TOWN OF BAY HARBOR ISLANDS PLANNING AND ZONING BOARD

April 17, 2018

Subject: Site Development Plan Application – Revision #1
Atlantis of Bay Harbor – 28 DU Multi-Family Residential Complex
10281 West Bay Harbor Drive
Bay Harbor Islands Acct. No. MB2017-21
MMPA Acct. No. 01-0702-1049

Below are all of the changes since the PZ Board approved the plans on March 21st, 2017:

DRAWING TITLE
ROOF LEVEL FLOOR PLAN
SCALE: - DATE: APRIL 3, 2018
SHEET NUMBER
A-108
P&Z REVISIONS

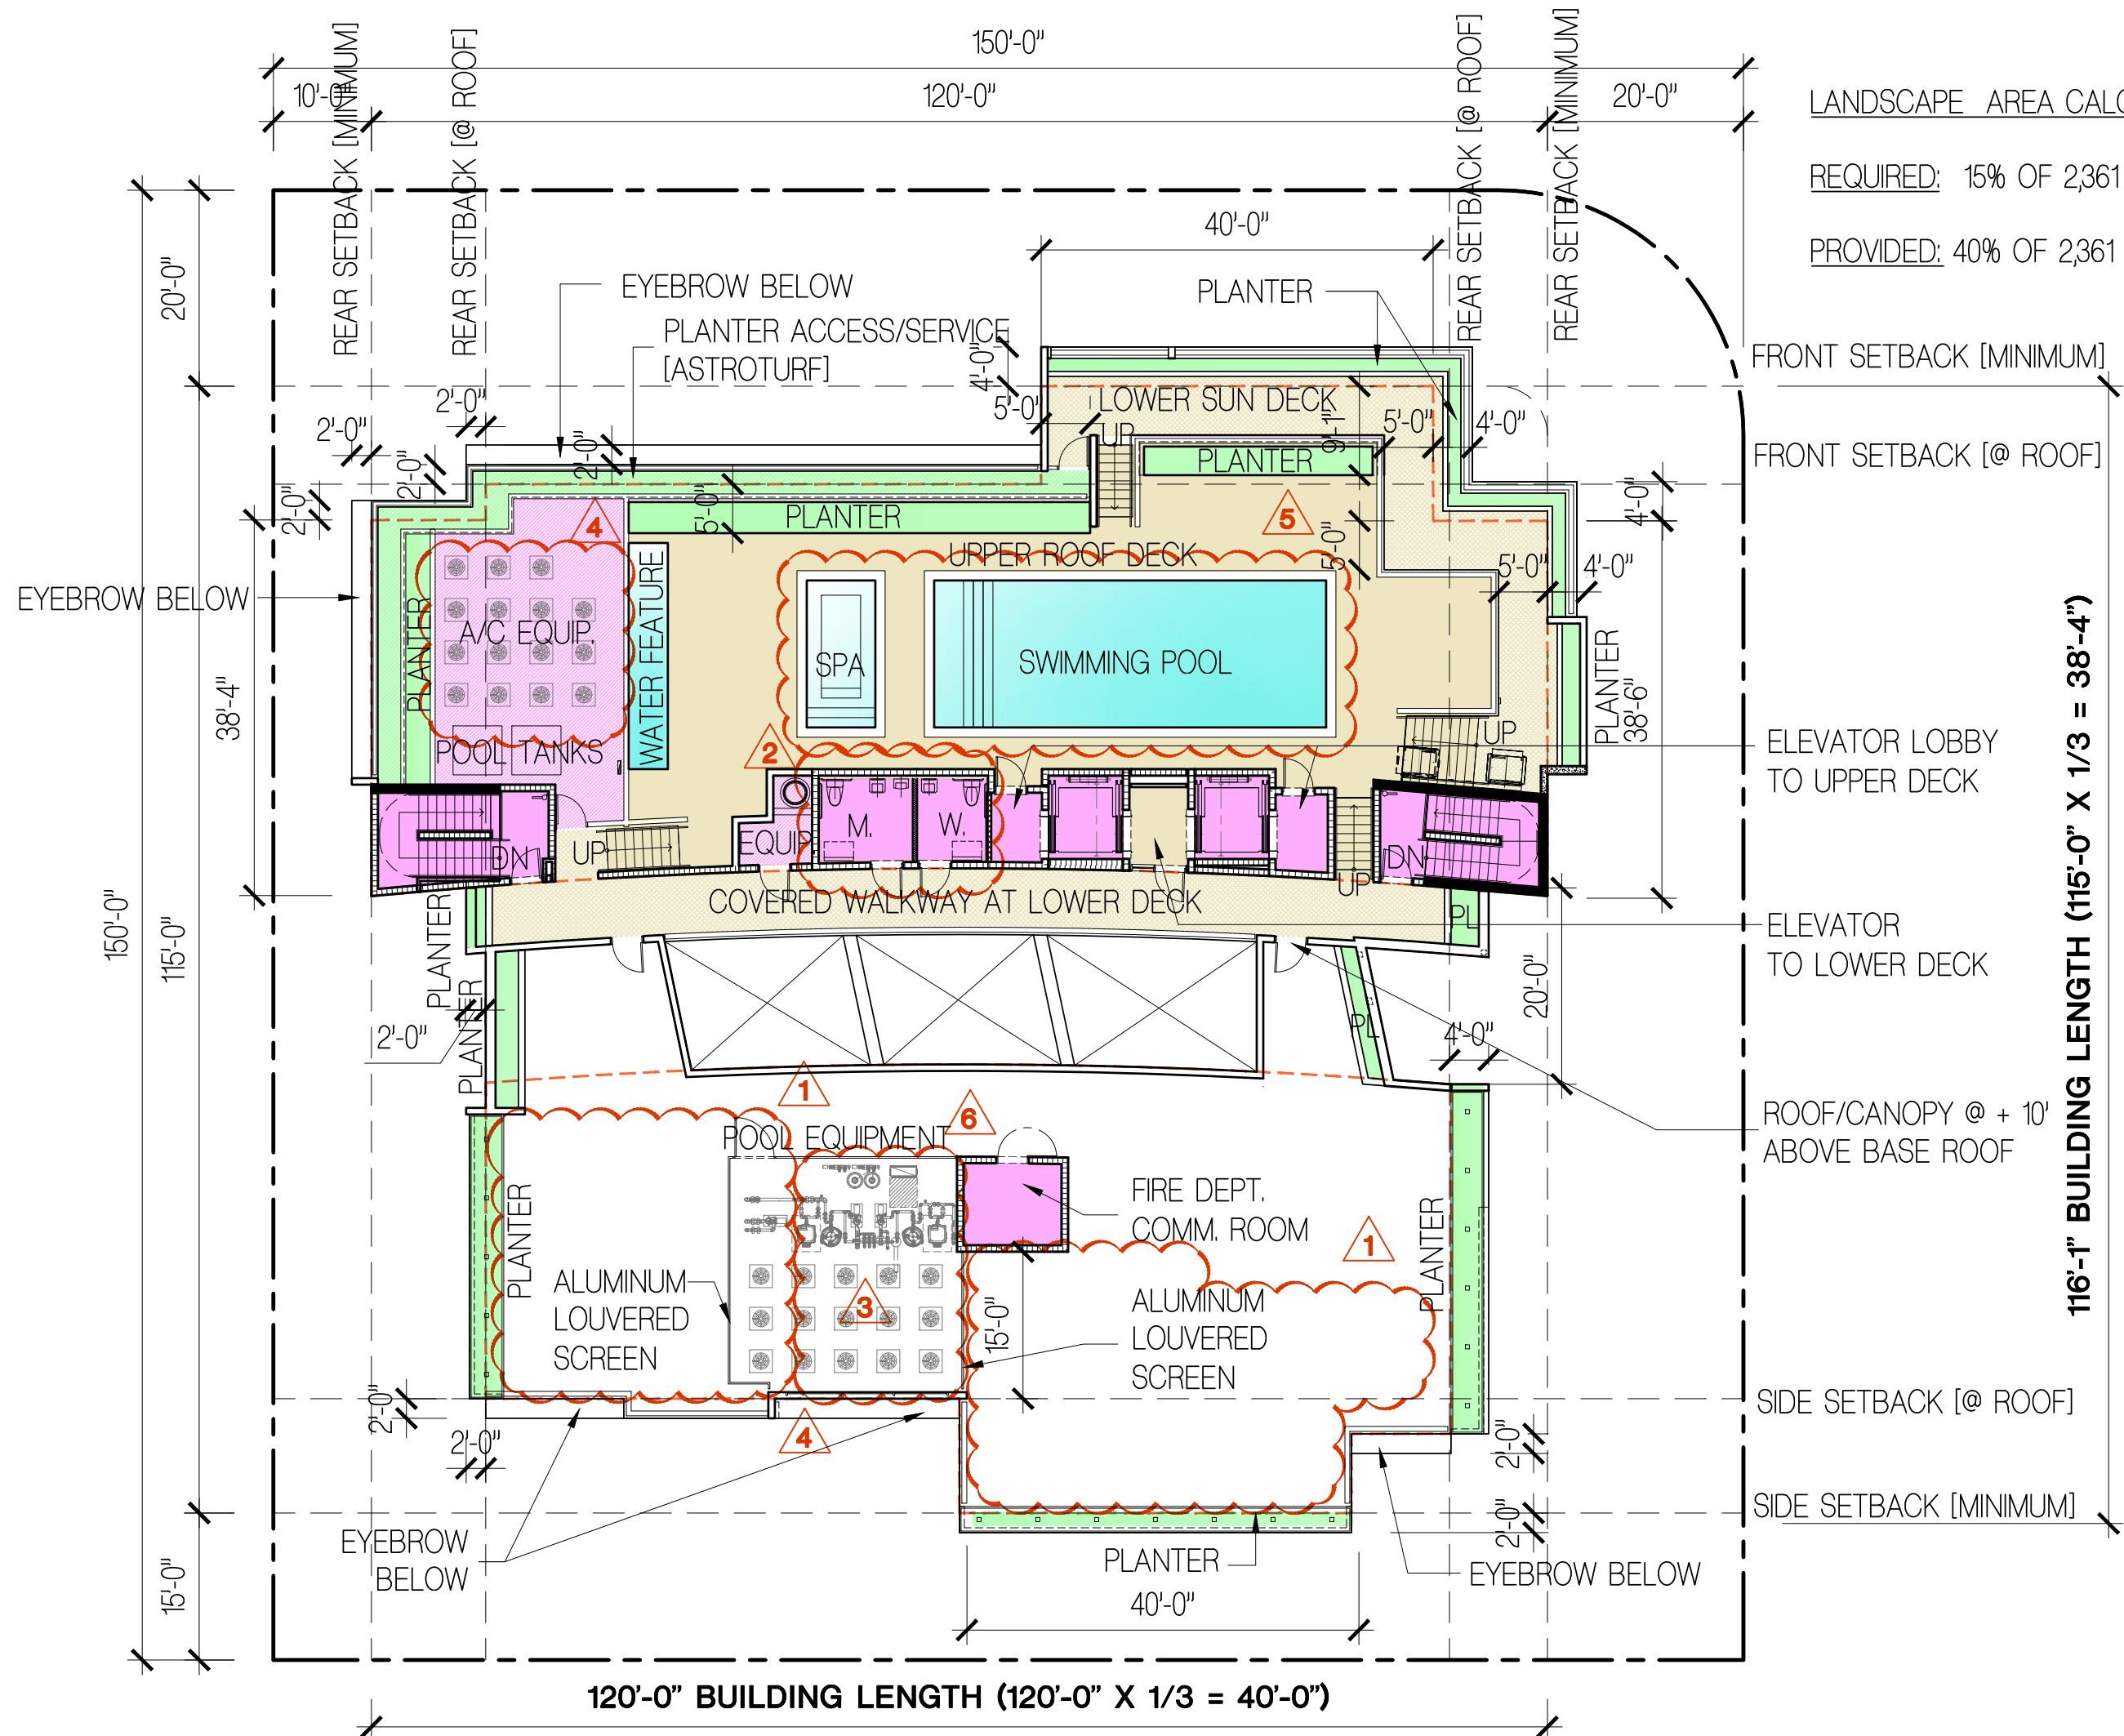
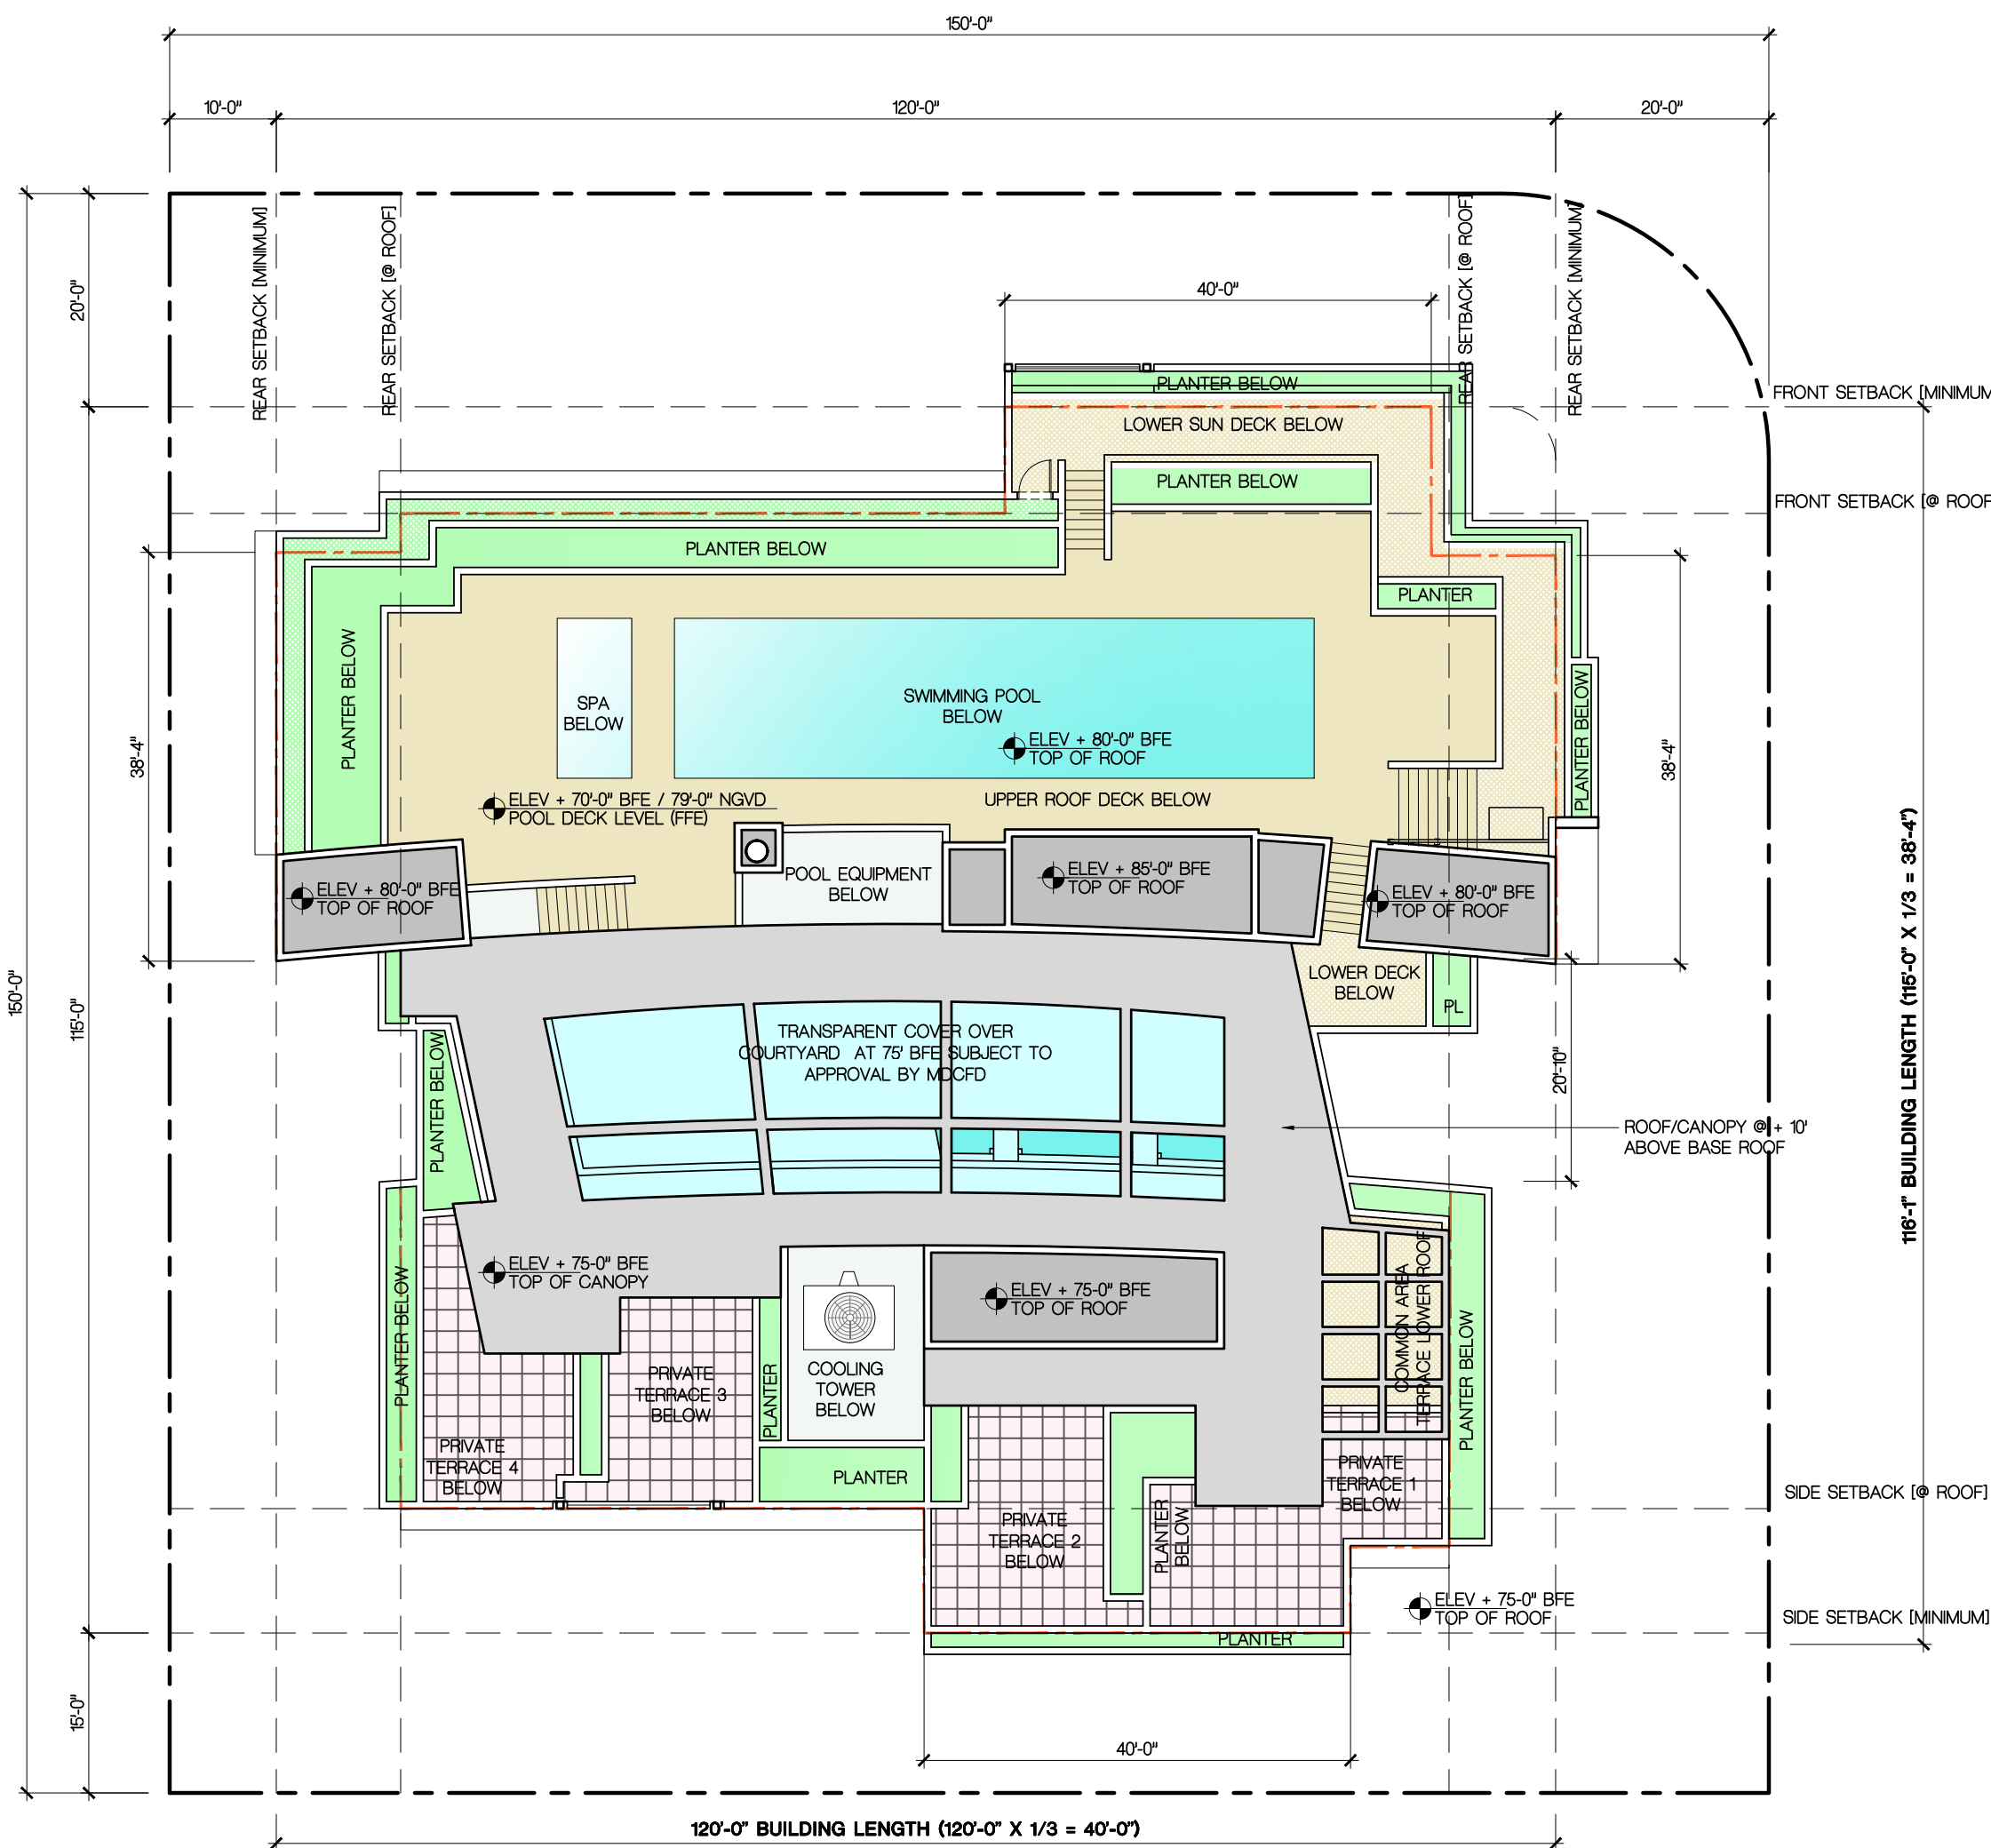
- 1 ELIMINATED THE 3 PRIVATE TERRACES ON THE NORTH
- 2 RELOCATED THE BATHS FROM THE NORTH TO THE SOUTH.
- 3 ELIMINATED THE COOLING TOWER ON THE NORTH.
- 4 ADDED CONDENSING UNITS ON THE NORTH AND SOUTH.
- 5 REDUCED SIZE OF POOL.
- 6 RELOCATED POOL EQUIPMENT FROM THE SOUTH TO THE NORTH.

SIGNATURE		DATE	
NO.	REVISION	DATE	BY
DRAWING TITLE:			
UPPER ROOF FLOOR PLAN			
SCALE	-	DATE	APRIL 3, 2018
SHEET NUMBER			
A-1.09			
P&Z REVISIONS

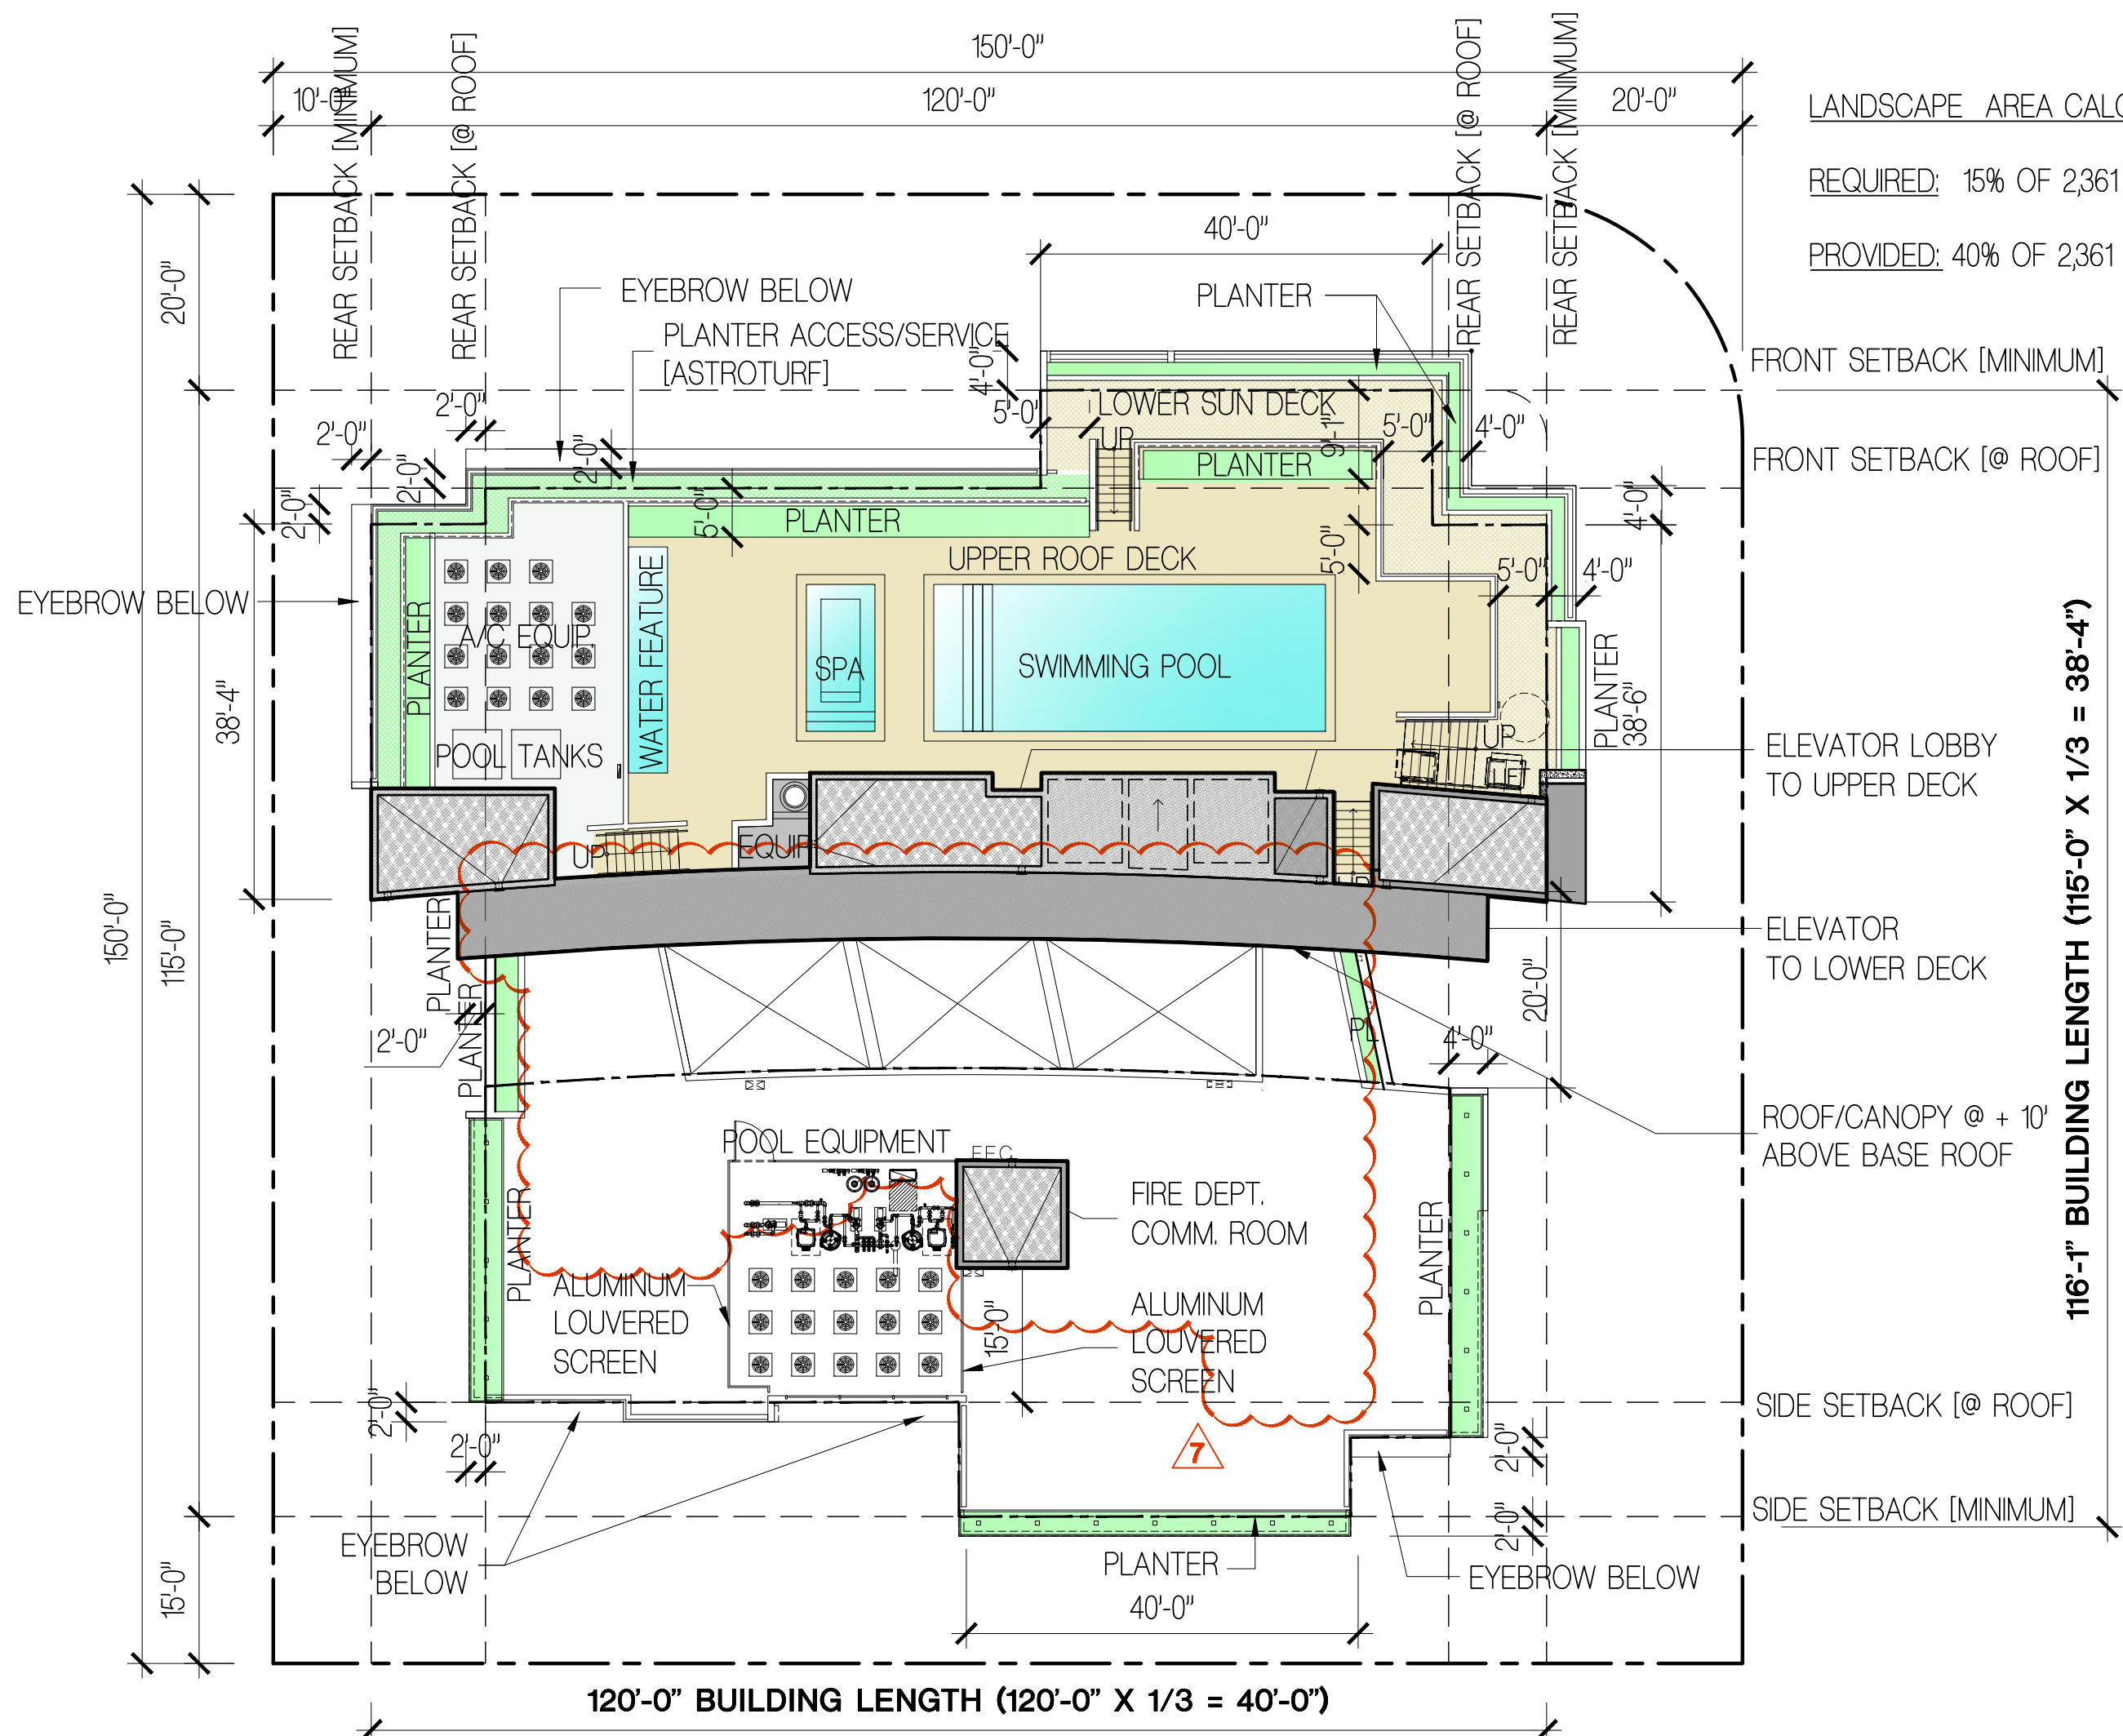
ELIMINATED THE 3 PRIVATE TERRACES ON THE NORTH

RELOCATED THE BATHS FROM THE NORTH TO THE SOUTH.

ELIMINATED THE COOLING TOWER ON THE NORTH.

ADDED CONDENSING UNITS ON THE NORTH AND SOUTH.
